FINAL PEER REVIEW REPORT

REEVALUATION OF MINIMUM FLOWS FOR THE
LITTLE MANATEE RIVER SYSTEM

AGREEMENT NUMBER: 19CN0001936

SOUTHWEST FLORIDA WATER MANAGEMENT DISTRICT
2379 BROAD STREET
BROOKSVILLE, FLORIDA 34604

Figure 2-3. Model Grid Overlain onto Aerial Photography

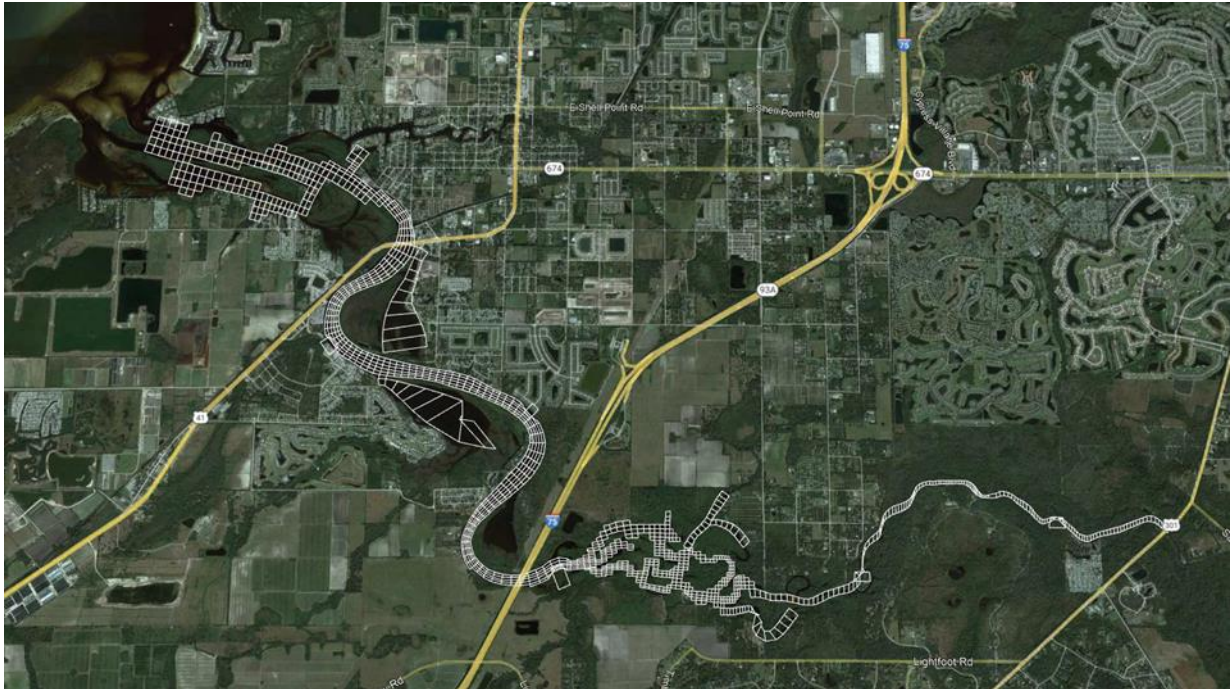
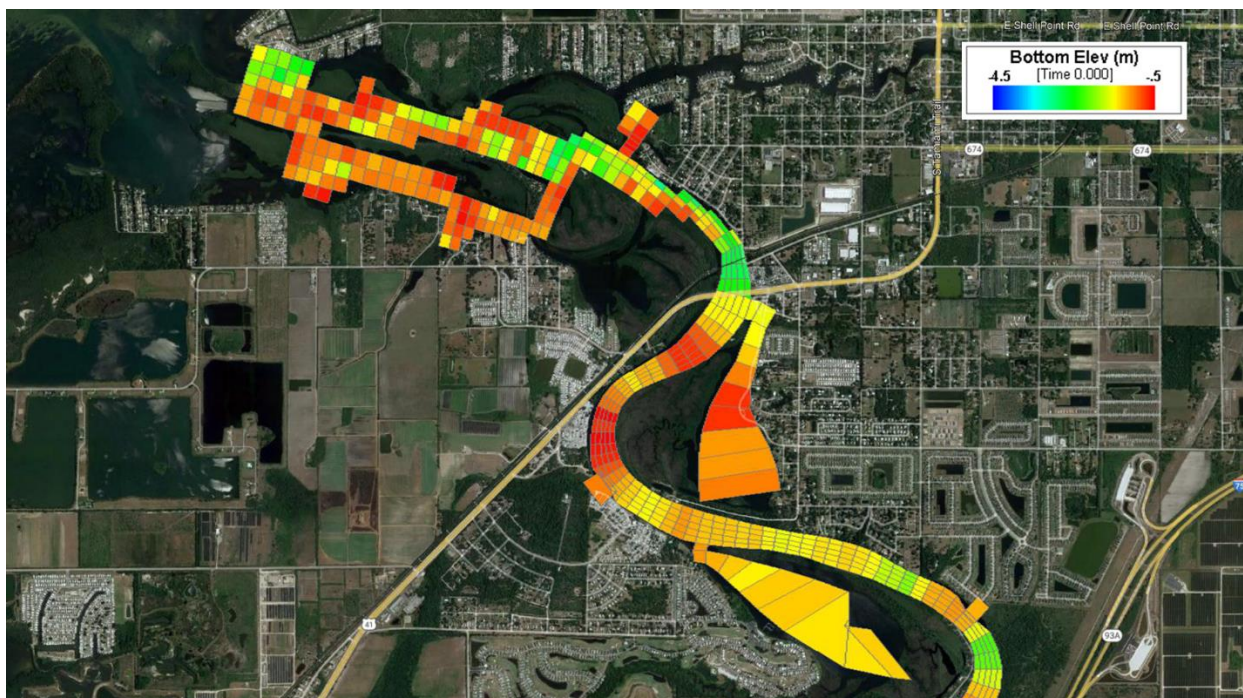
For mechanistic models of this type, a key aspect is that the grid developed provides a reasonable and accurate physical representation of the system. Figure 2-3 presents the EFDC model grid overlain onto an aerial of the estuarine portion of the Little Manatee River. The program utilized to transform the available model input files into a representation of the grid in some areas is not completely accurate, but overall, the recreated grid represents what is in the model.

Examination of the grid in relation to the shoreline of today shows areas where the physical representation does not match the actual conditions horizontally. This is especially evident in the area between the mouth up to US 41. This can be seen in the figure as well as in the original grid plots presented within the Huang and Liu report. In this area the sinuosity of the channel is not represented. Upstream of US 41 while the grid does generally follow the primary river channel, the grids extend outside of the channel into tidal marsh areas and in some instances upland areas. Figure 2-4 presents the depths as represented in the model. Examination of this figure identifies that the model, in a number of areas, is flat across the cross sections with no true channel geometry defined. This is most likely not an accurate representation of the overall system geometry.

One aspect of the model is that there is no wetting and drying being simulated. Examination of the model input files indicates this function is turned off. Wetting and drying is where the model simulates areas of tidal marsh that flood and drain throughout the tidal cycle. Examination of the aerial photographs indicates there are potentially significant areas of tidal marsh adjacent to the system. While the model does include some side storage areas, it

would appear that overall, a number of areas are not being simulated. This would relate to the accuracy of the tidal prism being simulated.

The model is utilized to calculate area and volume changes, so an analysis should be conducted to provide a comparison of the model areas and volumes with the actual volumes and areas in the system. A recommendation would be to calculate the longitudinal cumulative volume and area from the river mouth in the model (by river mile) up to US 301 versus actual inundated volume and area calculated from available shoreline, light detection and ranging (LiDAR), and bathymetric data. This should include adjacent tributaries as well as potential areas for flooding and drying in the adjacent marsh areas.

District Response: Comparisons of cumulative volume and area for the updated EFDC model, including adjacent tributaries, are included in an appendix (JEI 2023) of the revised draft report. The updated model also simulates wetting and drying. The slight over-representation of the river width in the upstream area of the Lower Little Manatee River was corrected in the post-processing when salinity habitats were calculated.

Review of Response: Within Appendix L graphics are provided that present by river mile the bottom surface area and volume as represented in the model in comparison to actual bottom area and volume based on available data. These comparisons, along with the finer grid resolution provided, demonstrate that the model is reasonably representing the physical conditions in the system and addresses the comment provided.

Figure 2-5: Measured Surface and Bottom Salinity Boundary Condition

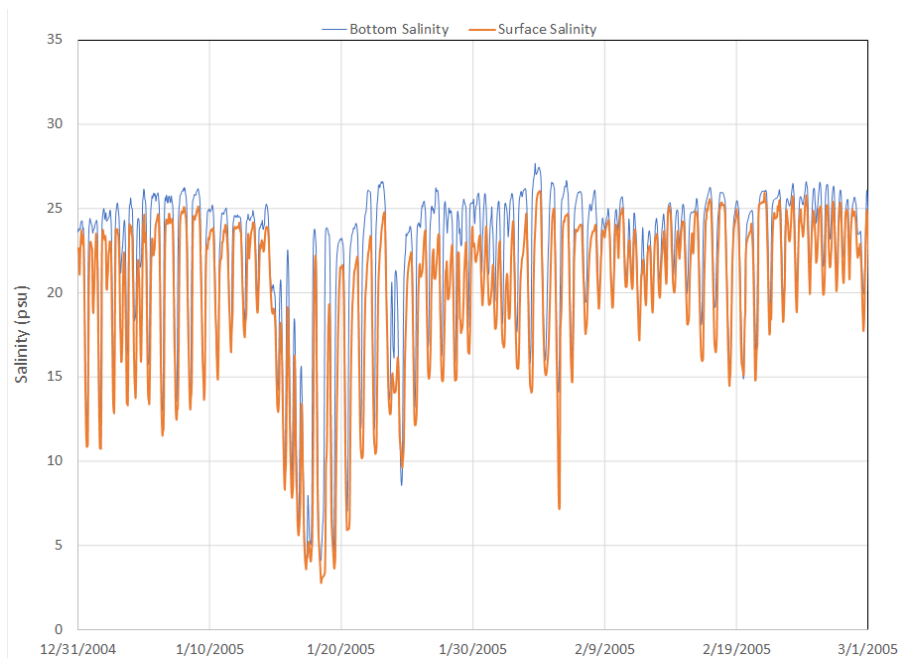
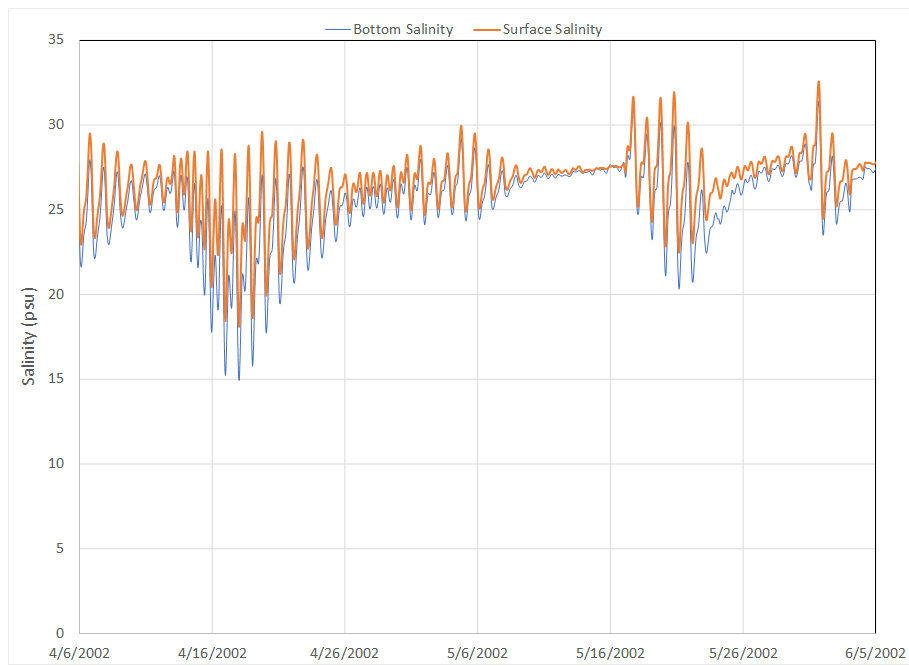
For the MFL baseline run and the flow reduction runs it was determined that the boundary conditions in the model are a mixture of measured data (for the period from around March 2004 through 2005) and data generated from regressions developed by HSW. This was not documented in any of the supporting materials. Figure 2-5 presents a plot of the surface and bottom salinities for 60 days where the measured data were utilized. Figure 2-6 presents a plot of the surface and bottom salinities where the boundaries were derived from the HSW regression. Examination of the plots shows two things. First, it appears for the boundaries created using the HSW regression, an error was made and the bottom and surface salinities appear to have been flipped. Second, the overall behavior of the boundary in the regressed condition does appear to match that seen in the measured data. It should be noted that for the MFLs, the HSW regressions were updated and per the documentation provided improved.

Recommendations: Runs should be performed to determine if the error is fixed if it would change the results of the simulations. It is likely that this error will not have a significant impact on the overall calculations due to the generally small degree of stratification in the system, but the District must determine the defensibility of carrying this error forward if the

analyses are not fully redone with the fixed boundary condition. Additionally, the regression utilized for the generation of the boundary conditions should be utilized to calculate the boundary condition during the period of the measured data and the two compared. This will allow for an assessment of the reasonableness of the created boundary for MFLs determination.

District Response: This problem does not exist in the new EFDC model simulations. The salinity boundary conditions in the updated model are from another hydrodynamic model for Tampa Bay and not from the HSW regressions.

Review of Response: The error in the boundary condition pointed out in the original comment does not exist in the new model. Review of Appendix L has demonstrated that the new model boundary condition addresses the comment provided above.

Figure 2-11. Area of Inundated Vegetation (green) as a Function of the Percentile Flow at the USGS Wimauma Gage. USGS flow gages are shown as red triangles. From Janicki Environmental, Inc., 2016.

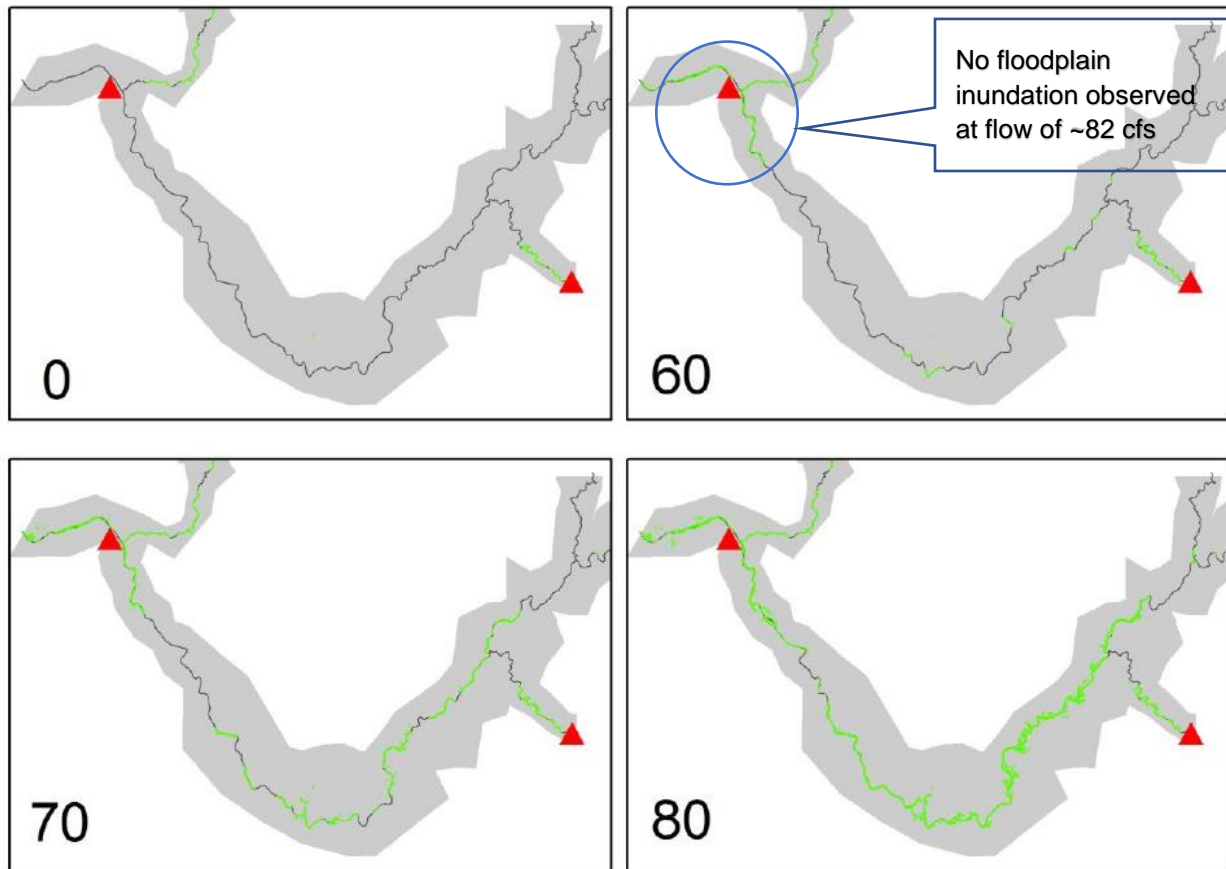
Furthermore, during field observations conducted on October 15, 2021, flow at the USGS Wimauma gage was about 82 cfs, which would be within proposed block 3. Field observations were conducted at several locations, including the entire area along the main river channel circled in blue in Figure 2-11. No floodplain inundation was observed at any of

the visited locations. Flows were fully contained within the banks with significant freeboard suggesting much higher flows would be needed to inundate the floodplain. This raises the question of whether the 60th percentile flow (72 cfs) is properly supported as a high-flow threshold.

District Response: The revised draft report includes an updated floodplain inundation analysis and updated flow blocks for the upper river.

Review of Response: Section 6.2 of the revised report discusses the updated floodplain inundation analysis. This section mentions difficulties in determining, from available topography, whether inundated floodplain areas are isolated from the main river channel or hydraulically connected at a given stage. Due to these difficulties, District staff conducted a sensitivity analysis to identify flow thresholds that correspond to decreases in inundated wetland floodplain area. “For the analysis, percent-of-flow reductions that would result in a 15 percent decrease in the total inundated wetland areas were assessed for flows at and above the 1st percentile, 2nd percentile, ...up to 99th percentile”. The analysis found that for flows below the 68th percentile (~96 cfs at US 301), percent-of-flow reduction required to reduce the inundated wetland areas by 15 percent was insensitive to baseline flow percentile, suggesting that “overbank flooding does not start until the flow is above the 68th percentile...”. The updated Block 3 lower threshold was therefore set at 96 cfs at the USGS gage at Hwy 301, whereas the previous threshold was set at 72 cfs. The sensitivity analysis is a reasonable approach that sufficiently addresses the peer review comment.
